**ADDENDUM #3
BL063-26**

Replacement of HVAC Systems at the F. Wayne Hill Water Resources Center Operations Building

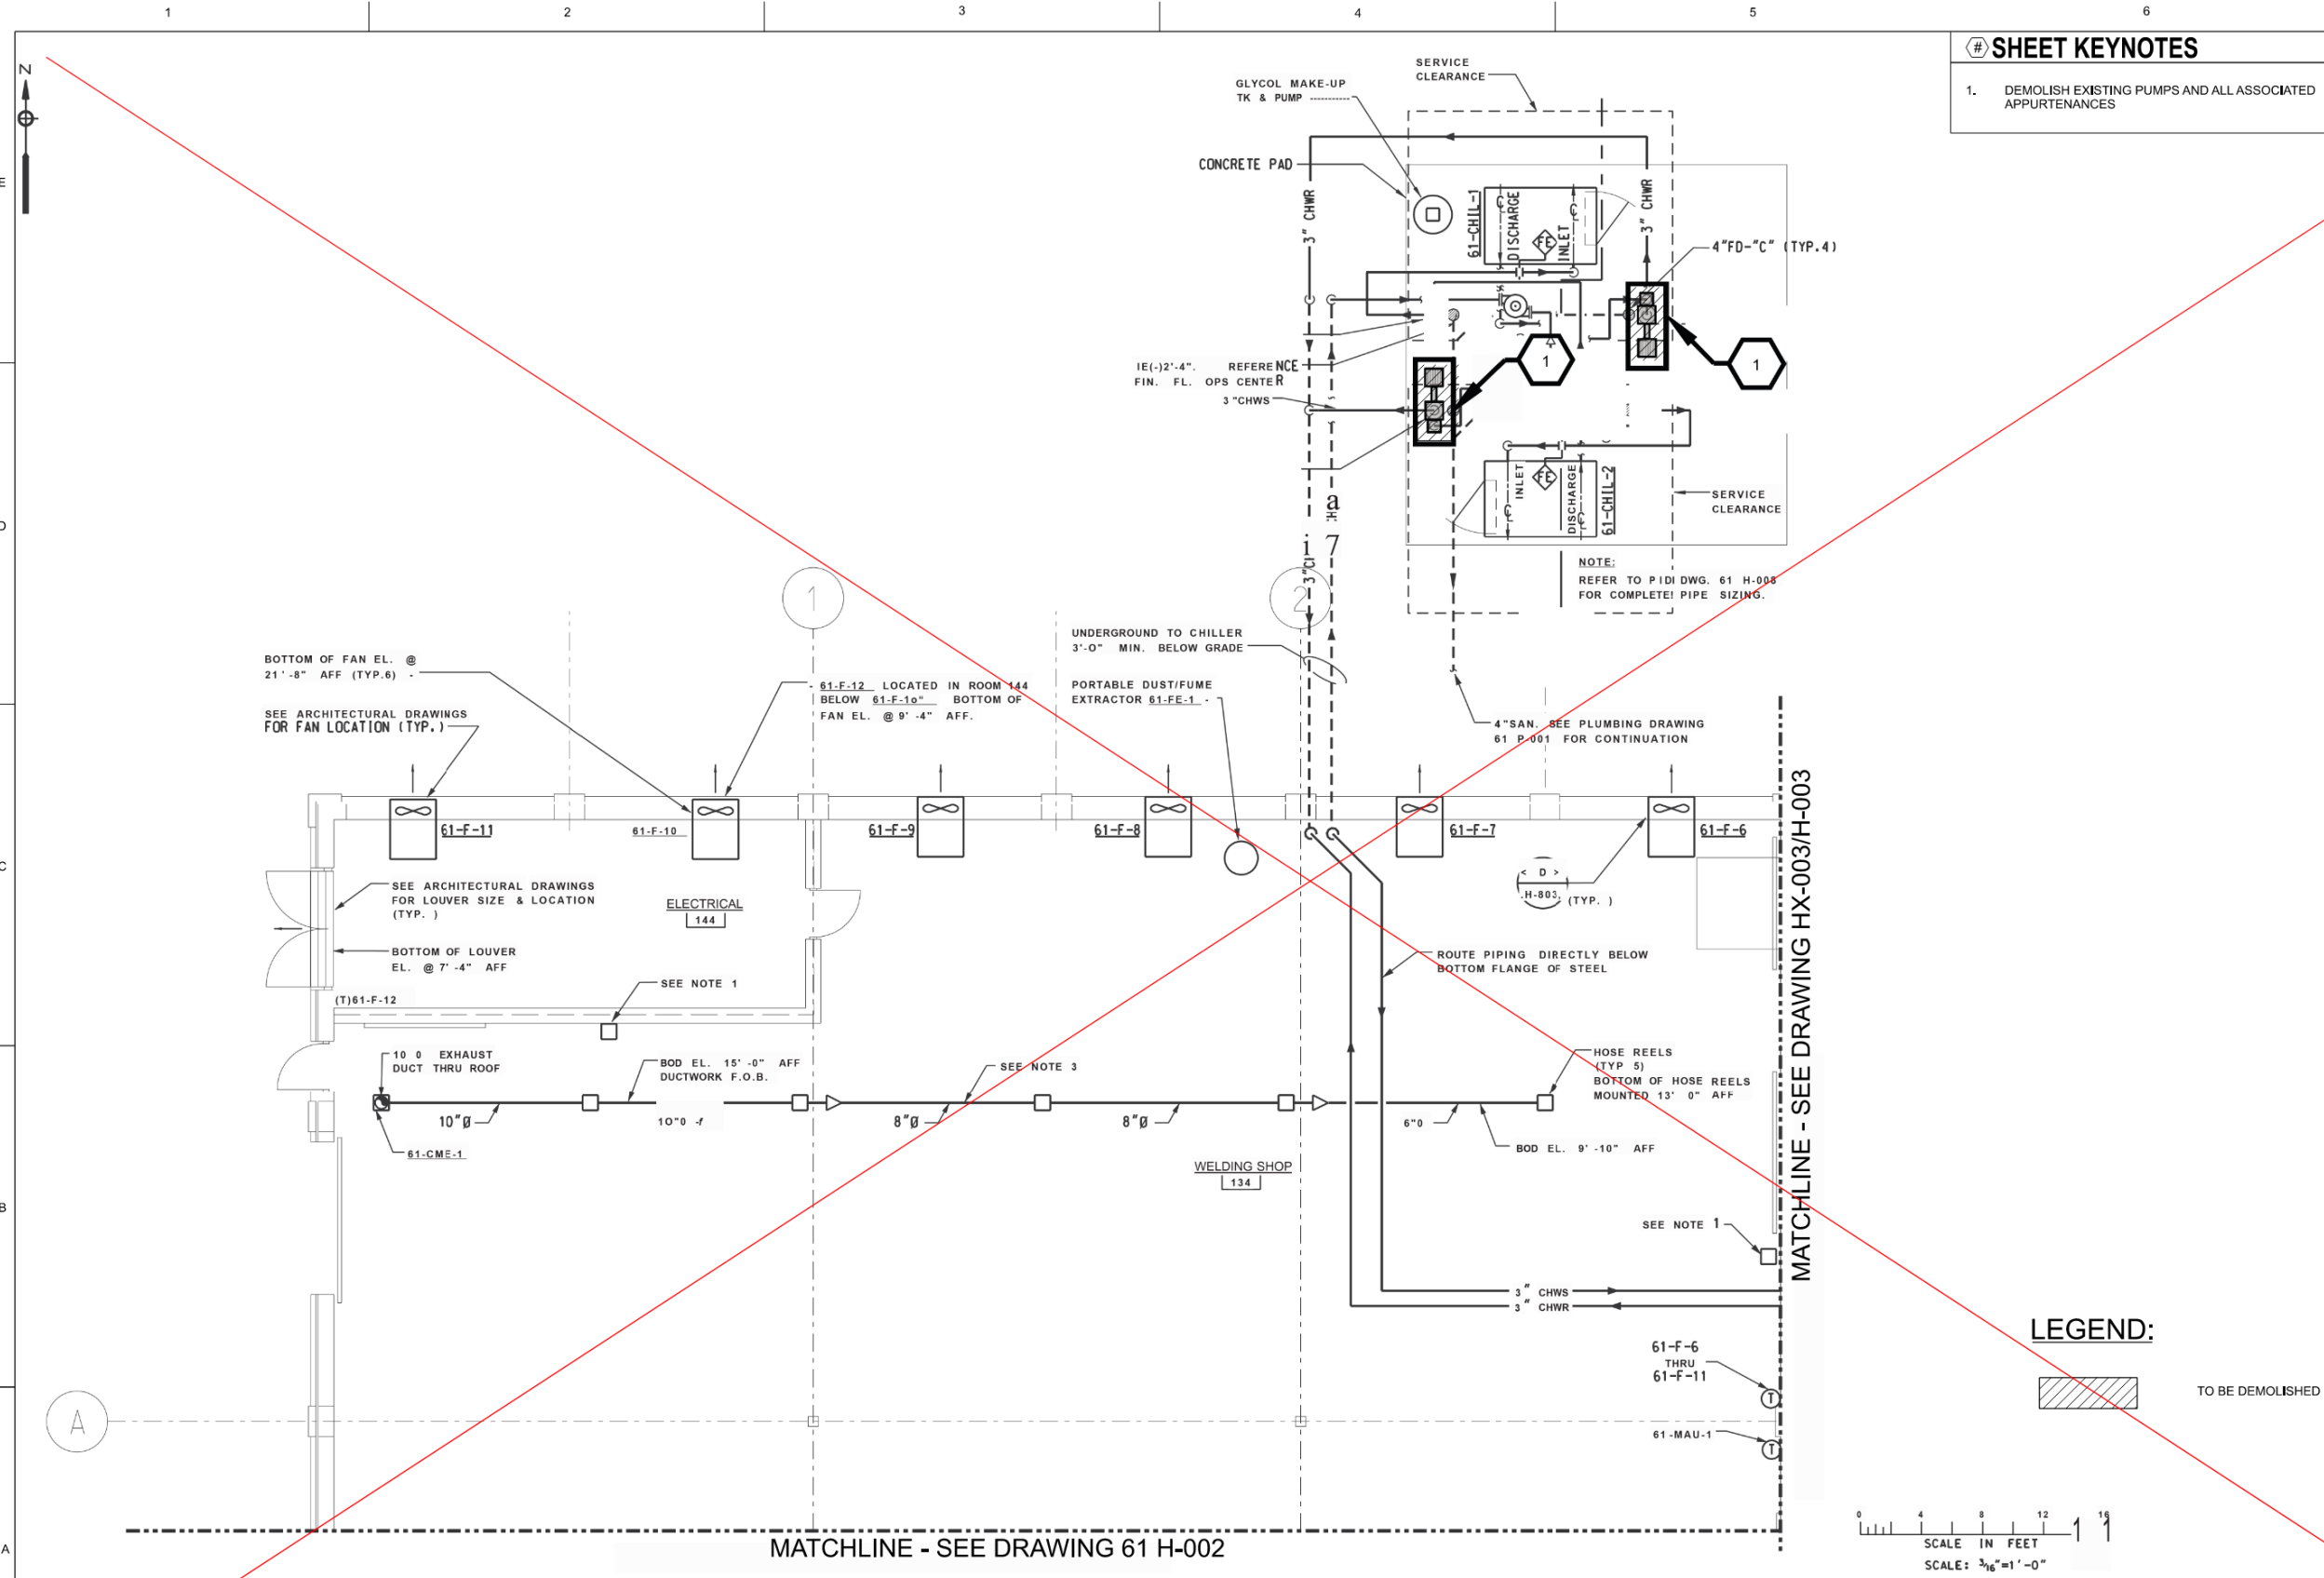
New set clarifies the Fans are to be replaced in kind. Fan Schedule provided on drawing H-008. New set also clarifies scale.

HX-001

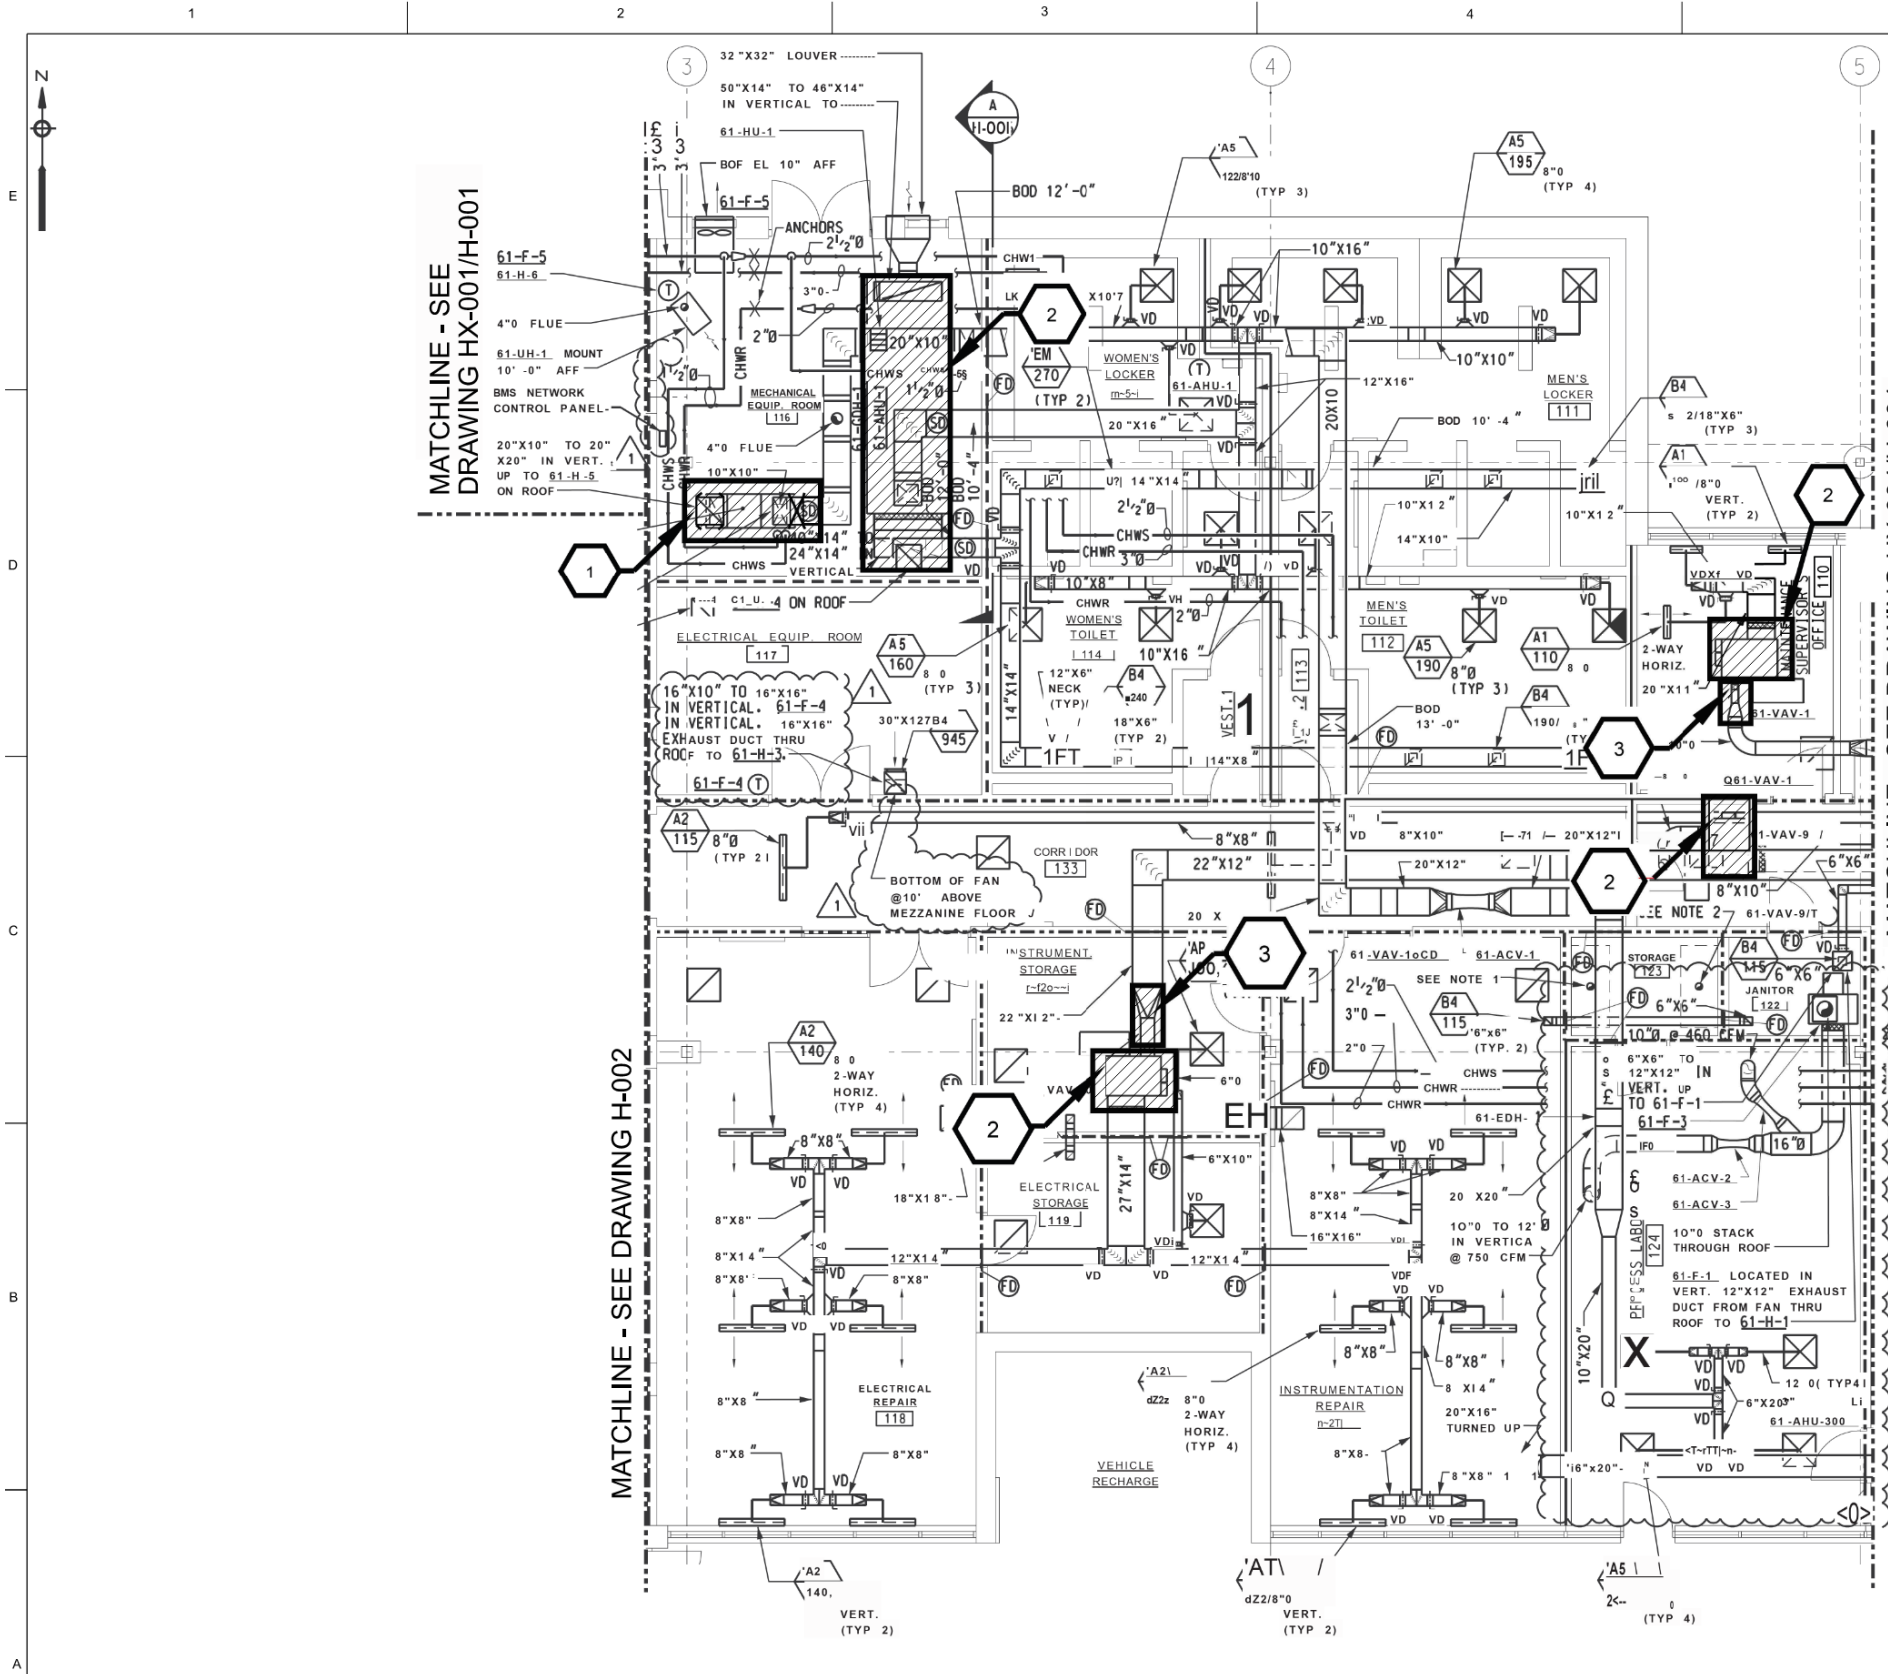
- Q7. The drawing page HX-003, H-002, and H-003 do not have accurate scales. Please provide an accurate scale. All other pages have two conflicting scales. Please confirm the correct scale.**

- A7. See revised Drawings included in this Addendum.
- Q8. Can another site-walk be scheduled?**
- A8. Please see Revision R2. A follow-up pre-bid conference has been scheduled to allow interested contractors to walk the site again.
